## FRYER Robert Blake

#### To Cheryl Moon Siriani:

I'd like to thank you for your February 2, 2018 letter to me politely disagreeing with my recommendation for Penn DOT to build the **left turn** stacking lane on Washington Pike in Bridgeville in order to help reduce the congestion at least one of the 3 major, economically ruinous traffic congestion SITES that have been ignored within the South Fayette, Bridgeville, Collier corridor communities for 5 decades.

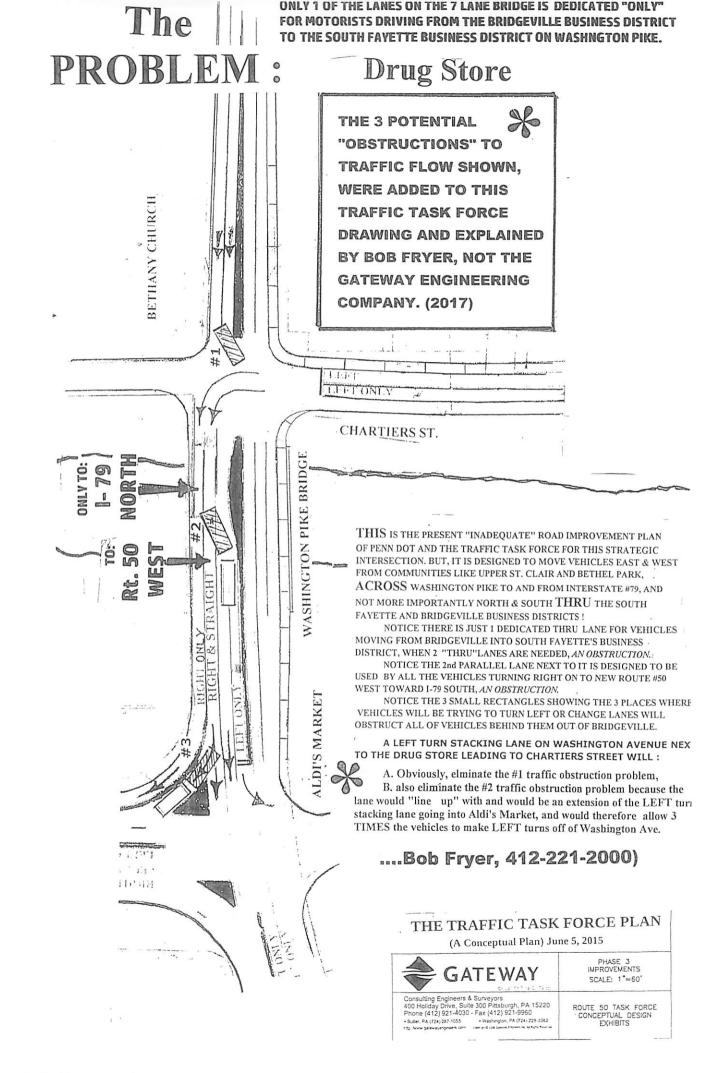
- 1. The new bridge will only have 1 Washington (Pike) Ave. lane dedicated exclusively for consumer-motorists from Bridgeville to enter South Fayette's central business district,
- 2. that there would be vehicles not able to "get completely into" the right lane on the bridge for vehicles moving to Route #50 West and I-79 South, that would block the 1 lane into the South Fayette central business district and
- 3. that there would be vehicles not able to "get completely into" the left turn stacking lane (on the bridge) leading to the Aldi Store shopping center, that would ALSO block the 1 lane into the South Fayette central business district from Bridgeville. **SEE DRAWING**.

This 1 Southbound lane can (and will) ALSO be periodically blocked by vehicles trying to get into the Route #50 West bound lane next to it, that have to stop before they are completely into the Route #50 West bound lane. SEE DRAWING.

2. Also, there is a Southbound left turn stacking lane to be on the new 7 lane wide bridge leading into the Aldi Store Shopping Center, that's on the other side of and next to THE 1 EXCLUSIVE LANE from Bridgeville leading to the South Fayette business district lane. And it's too short.

This means that some of these vehicles waiting to turn left will also be stopped before they are completely into the left turn stacking lane, and will ALSO block the 1 lane from Bridgeville into South Fayette's business district!

SHOWN ARE THE DANGEROUS OPTIONAL ROUTES MOTORISTS HAVE DEVISED THAT

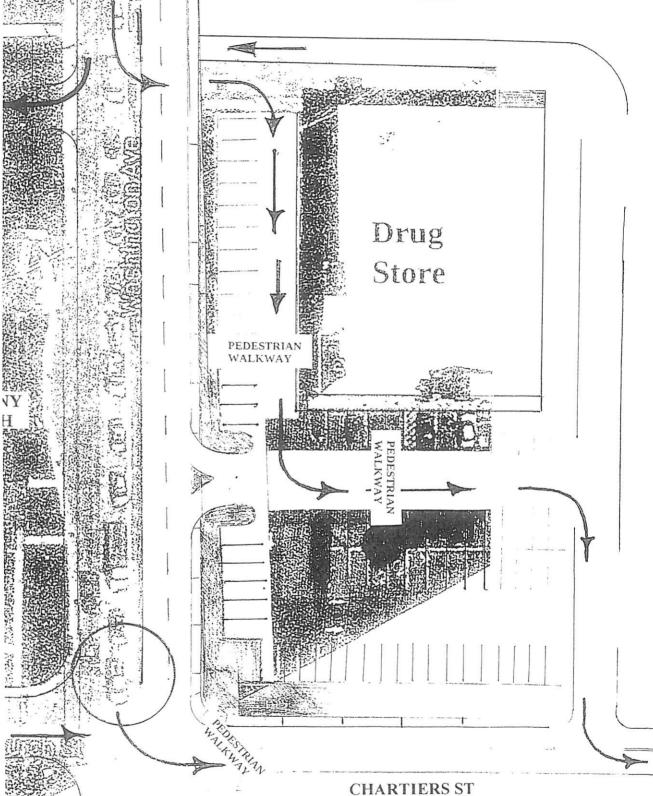
CROSS 4 PEDESTRIAN WALK WAYS, BECAUSE THERE IS NO LEFT TURN STACKING LANE ON WASHINGTON AVENUE ON TO CHARTIERS STREET.

Also, during our two 1 hour traffic counts, 3 additional Southbound vehicles on Washington Ave. turned RIGHT to drive around the Betheny Church thru its parking lot and in front of its rear door, to avoid the delay in turning left at the intersection, so they could then come up along side the Church St. and drive ACROSS Washington Ave. to Chartiers Steeet.

Also, 2 of the Southbound vehicles on Washington Ave. turned LEFT thru the drug store parking lot, to avoid waiting to turn left at the traffic light to Chartiers St. When the Rite-Aid officials visited the site last month, they witinessed the cars dangerously cutting thru their parking lot, in front of their main customer entrance.

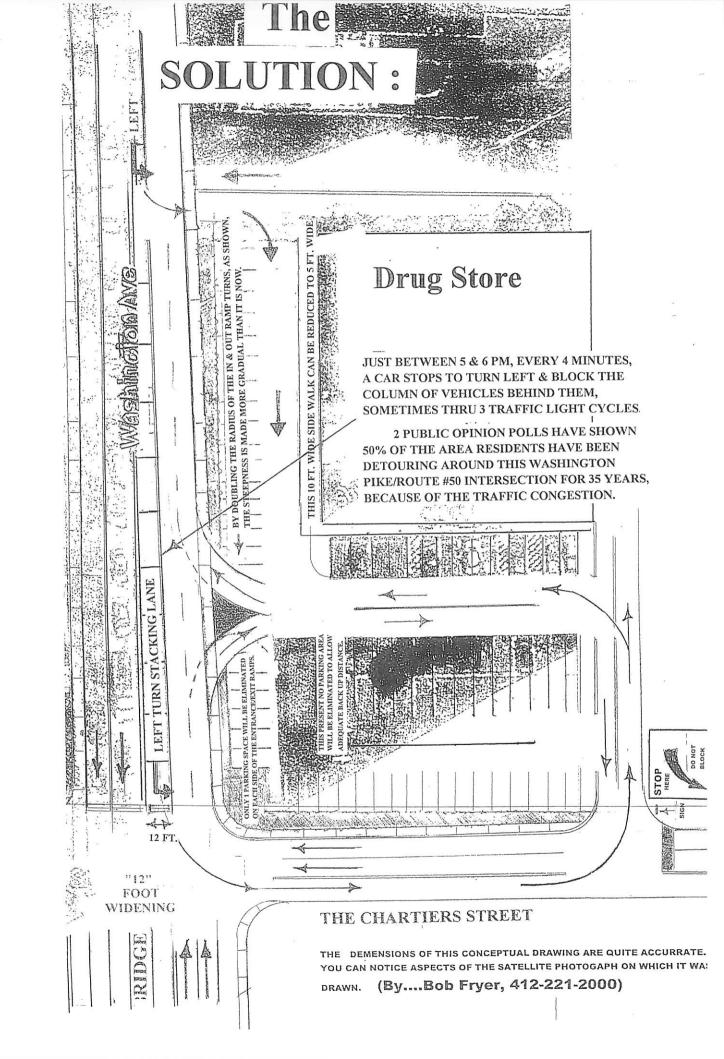
**D.** In your letter to me, you inferred that the Rite-Aid store's **main** curved entrance and exit ramps for consumer-motorists between Washington Avenue and the store WOULD HAVE TO BE ELIMINATED!

I would like to respectfully disagree, in that the **present distance** between the street and the store's parking lot is 36 FFET, and that the surface level of the parking lot is actually only 48 INCHES higher than the street.

ALSO, the **inside radius** of the present entrance and exit ramps is 20 feet, with a 10 foot long straight section to reach parking lot surface level.

By enlarging the inside radius of both ramps from 20 FEET to 36 FEET their lengths would be EXTENDED and their steepness would be decreased, making them easier for motorists to use than they are now. (Also, only 2 parking spaces would be sacrificed out of 72.) SEE DRAWING.

NECESSARY FOR THE "LEFT TURN STACKING LANE" TO BE BUILT. INSIDE EDGE OF THE WASHINGTON AVENUE SIDEWALK, THAT IS SHOWN BELOW IS THE PROPOSED NEW POSITION OF THE

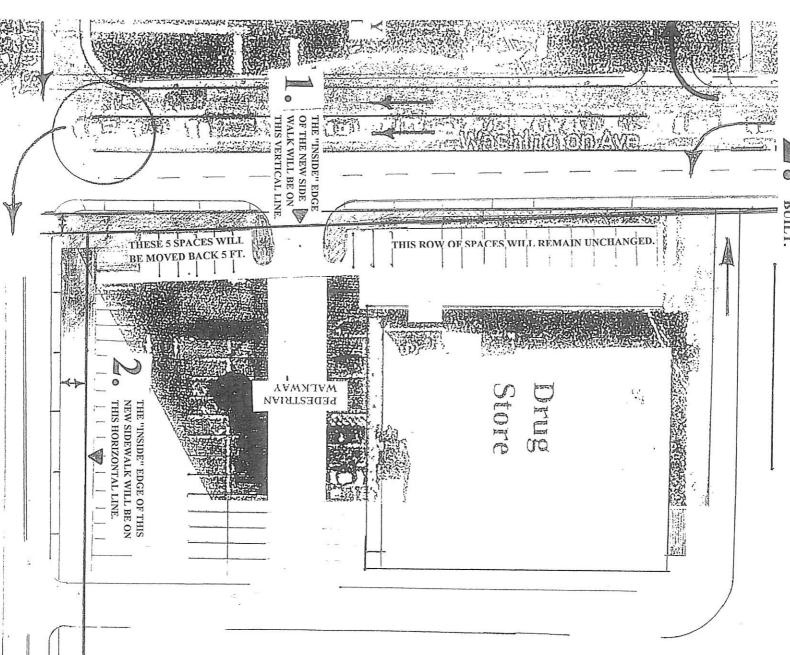
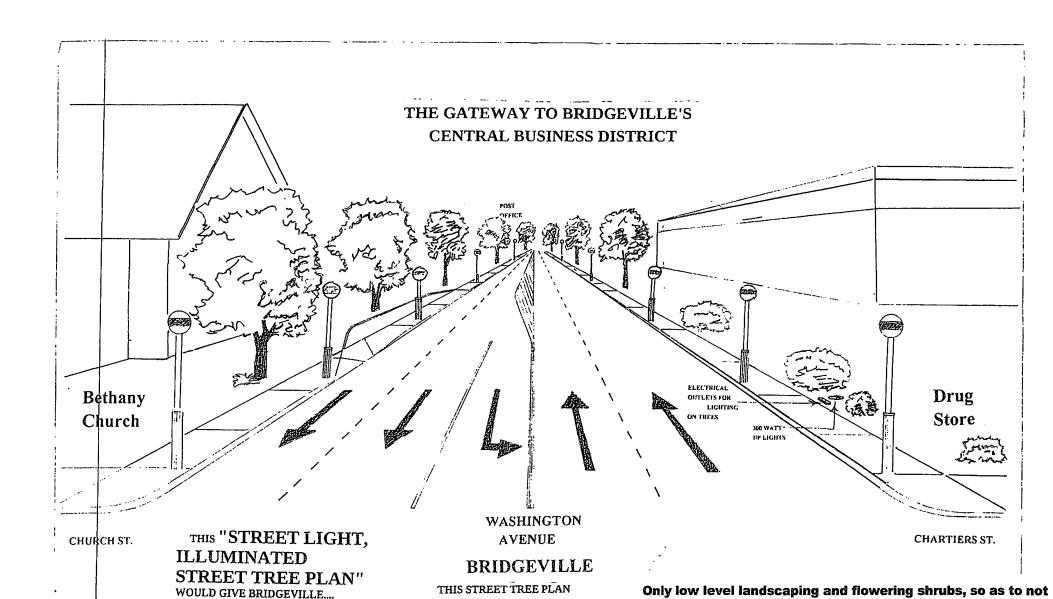
We defined the "new necessary position" of the inside edge of the new Washington Avenue sidewalk closest to the store as... a "tapered" straight line, from its widest 10 FOOT width closest to the Chartiers Street corner, decreasing to "0" FEET in width as it continued 450 feet further North, to the corner of James Street, across from the U.S. Post Office.

Therefore, the amount of property needed becomes less and less as the new sidewalk continues to the North. **SEE DRAWING.**

NECESSARY FOR THE "ADDITIONAL" STACKING LANE TO BE INSIDE EDGE OF THE CHARTIERS STREET SIDEWALK, THAT IS BUILT. SHOWN BELOW IS THE PROPOSED NEW POSITION OF THE
